Service Bulletin

Bulletin No. 2006-14
OEM No. 2006-04

Official Recall Notification U.S. Federal Boat Safety Act - Throttle Sticking on 25/30 EFI FourStroke Outboard Product

24728

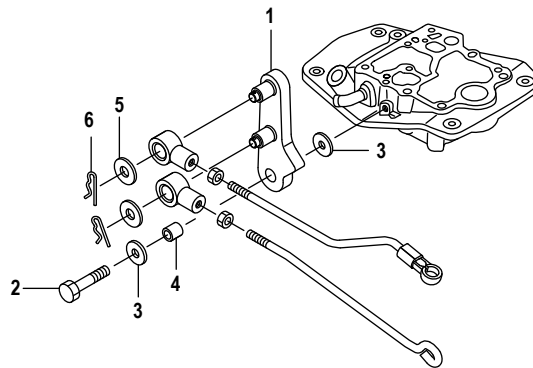
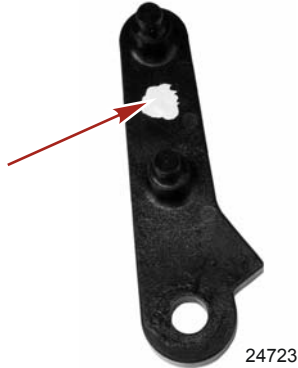
10. Remove the bolt, bushing, and washers from the throttle arm. Retain the throttle arm and bolt. Discard the bushing and throttle arm mounting washers.

- 1** - Throttle arm
- 2** - Bolt
- 3** - Washer (2) (discard)
- 4** - Bushing (discard)
- 5** - Washer
- 6** - Cotter pin (discard)

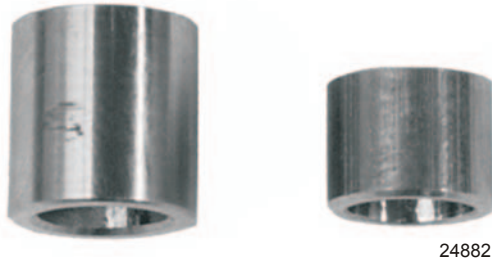
12. Install the larger bushing and washers supplied with this kit onto the throttle arm.
NOTE: The larger bushing is for the throttle arm and the smaller bushing is for the throttle opener.

Throttle arm bushing Throttle opener bushing

24909

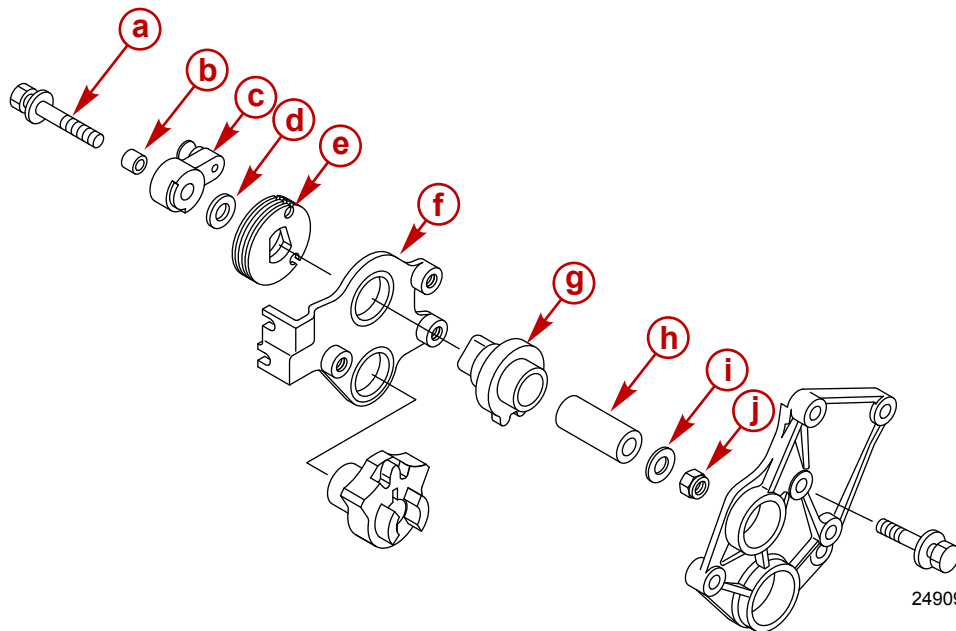
19. Remove the bolt and nut securing the throttle opener to the throttle only assembly.
20. Remove the throttle opener. Retain the washers, bolt, and nut. Discard the throttle opener bushing.
21. Install the new bushing provided in the bushing kit using the old bolt, nut, and washers. Torque the nut to specification.

Description	Nm	lb. in.	lb. ft.
Drive gear nut	6	53
